**Supplemental Proposals to Revising the
Northern California Metroplex
For Alameda County/Contra Costa County**

**Oakland Airport-Community Noise Management Forum
January 2017**

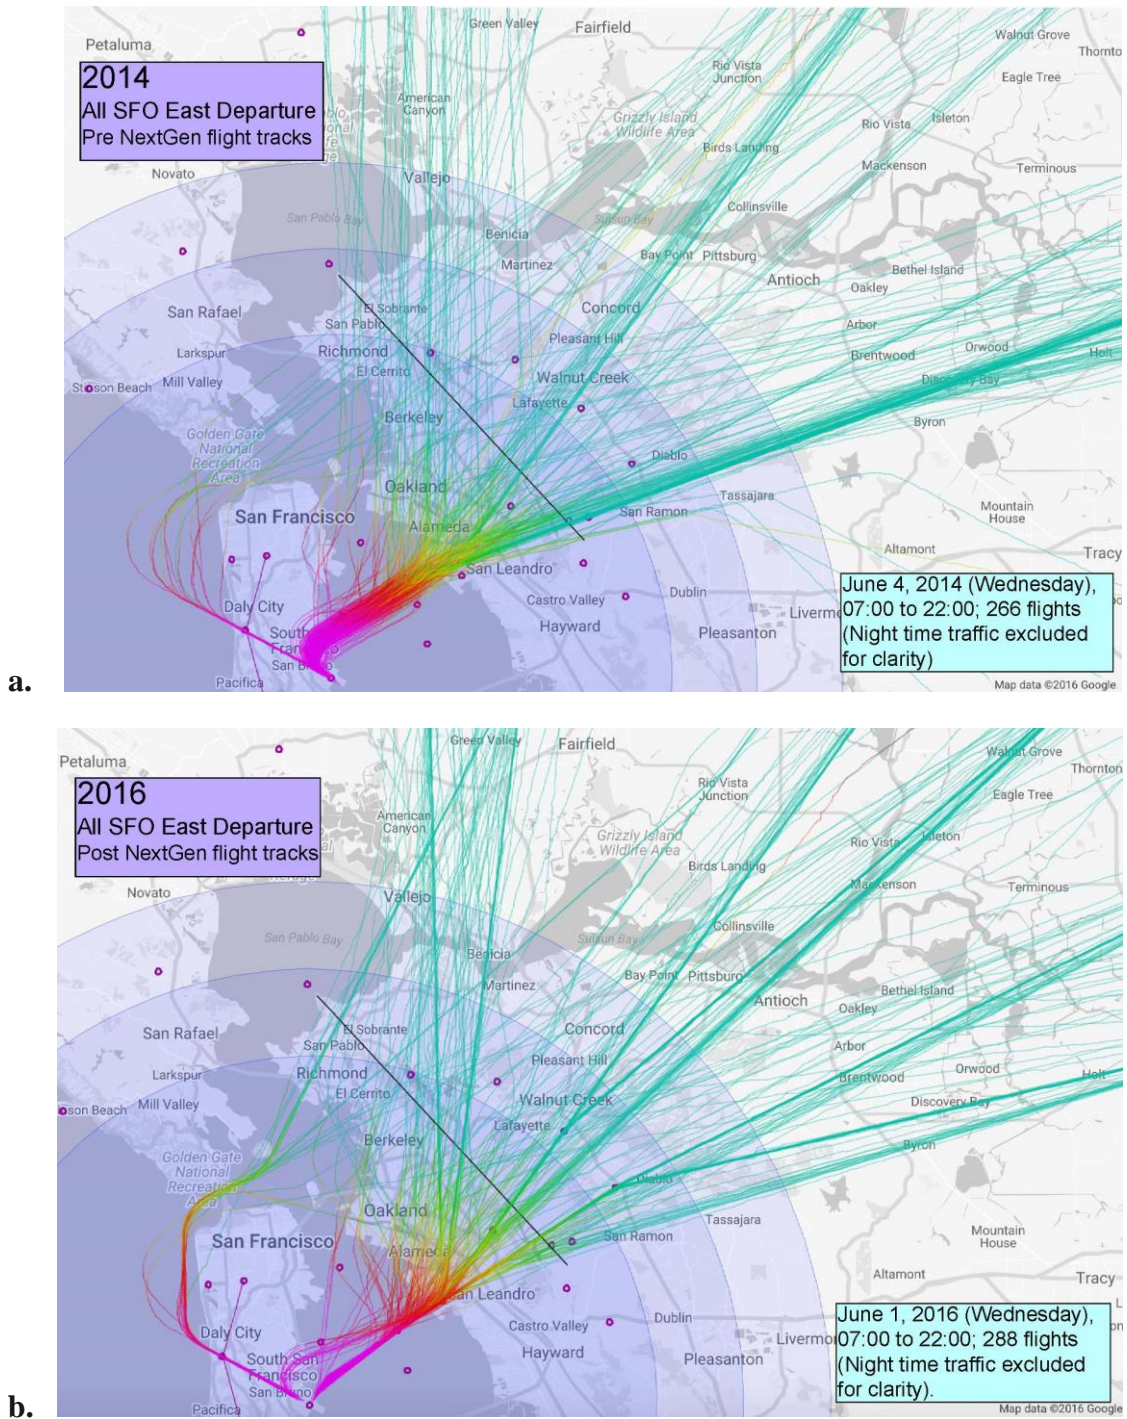
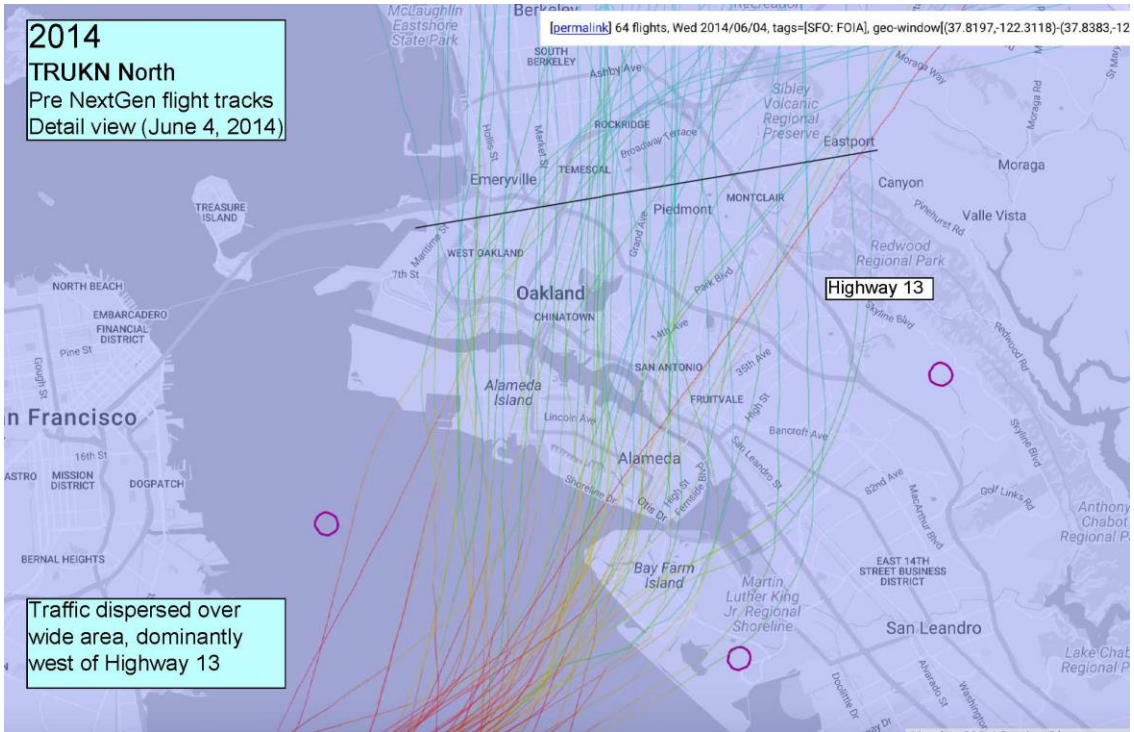
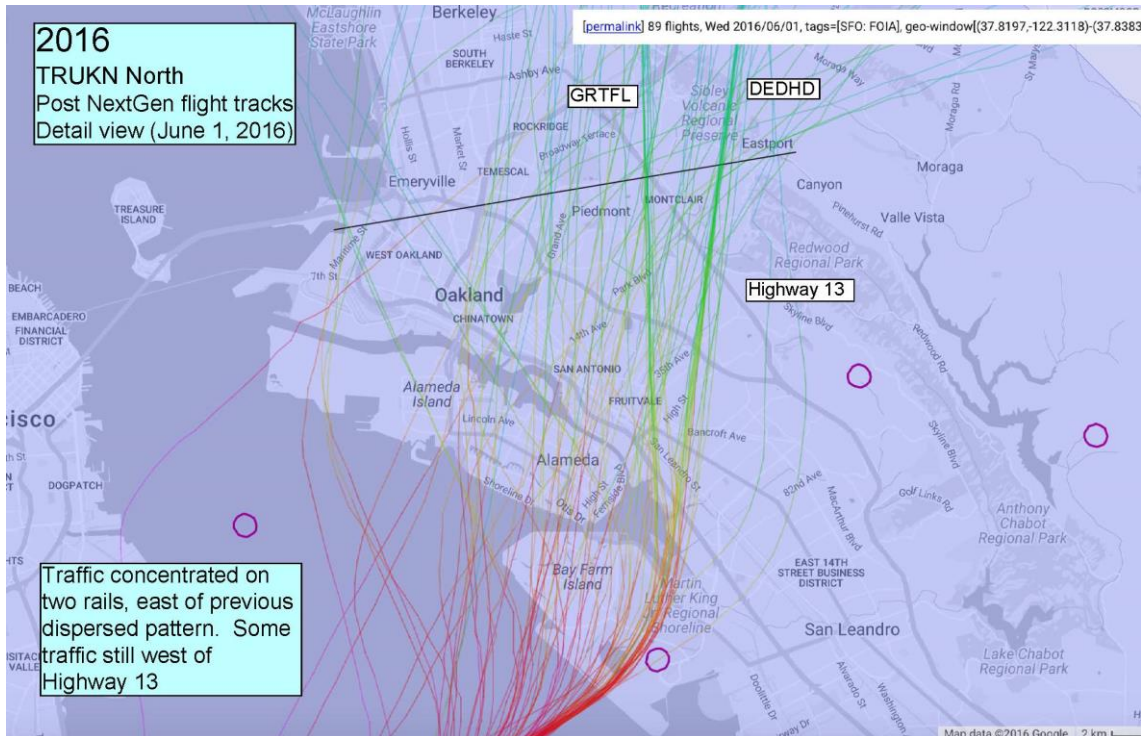
Prior to NextGen, SFO traffic in TRUKN North was vectored over a wide corridor from the San Francisco Bay to the Oakland Hills with the dominant majority of traffic concentrated over an almost due north corridor from Alameda and northward over West Oakland, the City of Piedmont, Berkeley and northwards (Figures 17, 18, and 19.) The turn northward after departure from SFO was further west over the Bay relative to the current TRUKN waypoint and kept traffic more westward than the current concentrated flight paths along GRTFL and DEDHD(compare Figures 18 and 19). The new procedure turned aircraft at TRUKN and shifted traffic from the Bay eastward. The new NextGen procedure also resulted in the lower altitude portions of the climb occurring over land and communities in Alameda, East Oakland and San Leandro instead of the Bay (Figure 17b).

The publication of GRTFL and DEDHD shifted traffic eastward from its historical pattern and concentrated it on two new RNAV tracks over the topographically higher areas of Berkeley and Oakland. These areas now experience dramatic increased aircraft noise resulting from concentrated traffic on these new RNAV tracks where it did not exist prior to NextGen.

The Forum requests that the FAA restore the historical traffic concentrations in the topographically lower areas where it existed prior to NextGen and that communities grew and developed under. To accomplish this, the Forum requests the FAA move the current GRTFL and DEDHD tracks westward of Highway 13 and East Oakland to reestablish and better restore historical patterns of SFO departing traffic in this area as the proposed mitigation (Figure 20). The Forum also requests the FAA adjust the TRUKN waypoint to better restore the legacy earlier turn northward over the Bay and keep the lower altitude portions of the climb occurring over water instead of communities in Alameda, East Oakland and San Leandro.

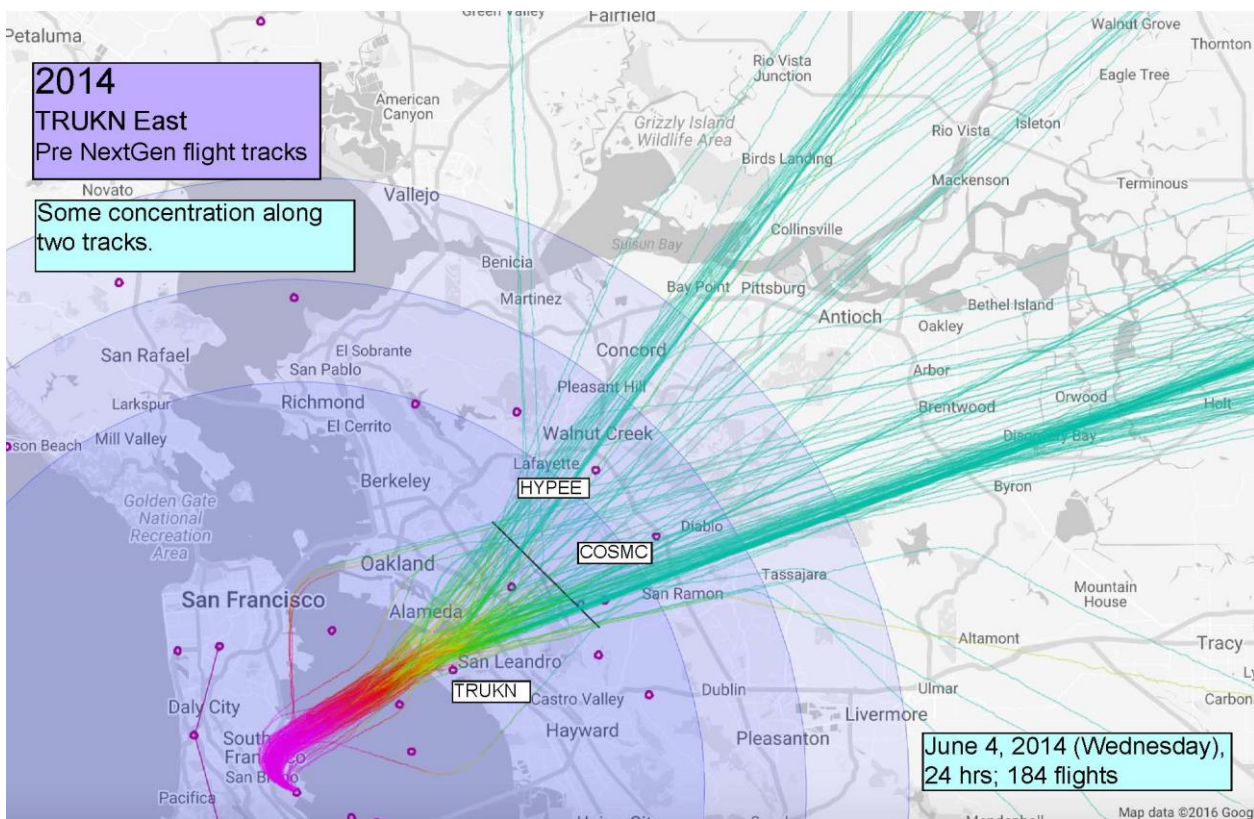
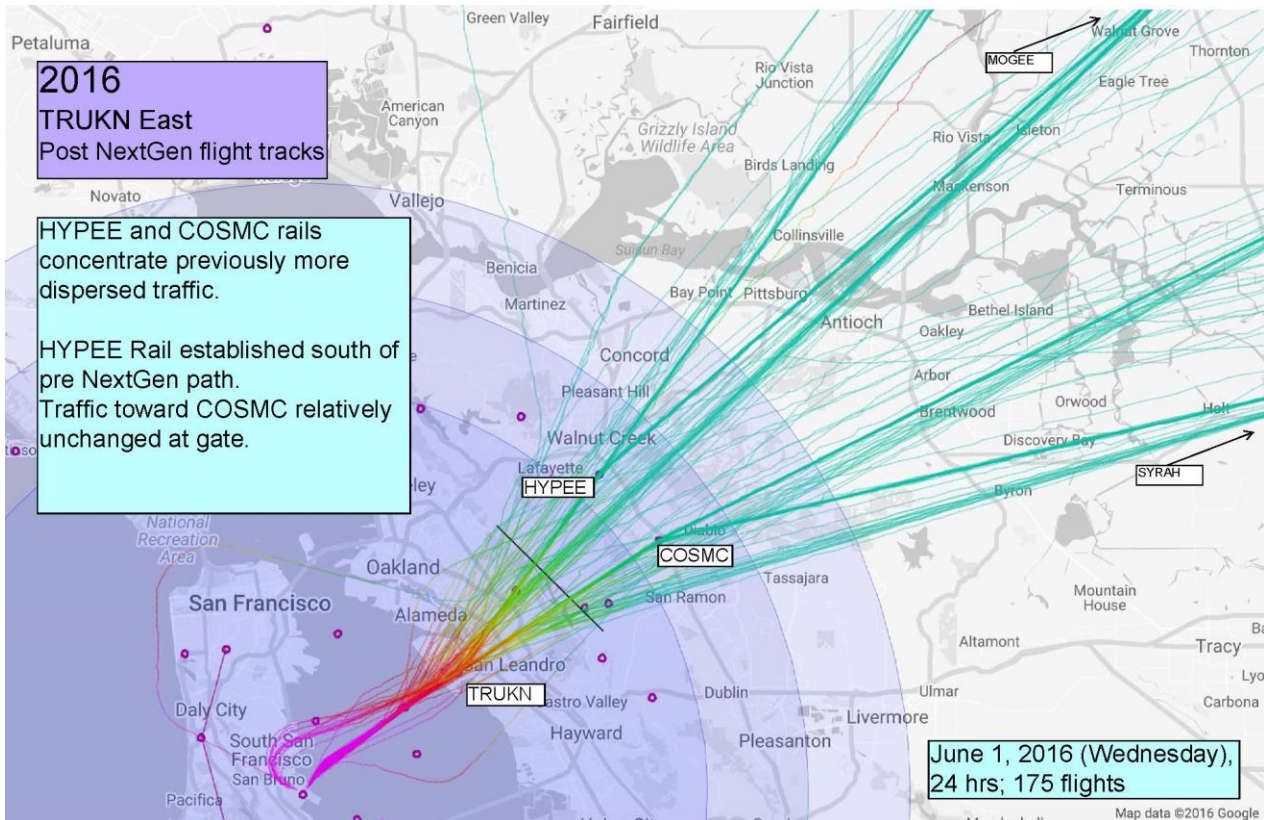
Examination of TRUKN East shows that prior to NextGen, SFO departing traffic was concentrated in two distinct corridors roughly corresponding to the NextGen HYPEE and COSMC RNAV tracks. However, there was a significant shift southeastward and concentration of traffic along HYPEE when it was published. This shifting concentrated traffic one mile south, and significantly increased noise for residential areas there.

The Forum requests the FAA restore historical traffic concentration where it existed prior to NextGen and where communities grew and developed under (Figures 21 and 22). To accomplish this, the Forum requests the FAA consider adding a track to the area of the existing COSMC and HYPEE tracks and adjust to better echo legacy concentrations. The Forum additionally requests that the FAA direct Air Traffic Control to vector traffic along all resulting tracks in the TRUKN East area to better echo and restore historical concentration and dispersion of SFO departing traffic.
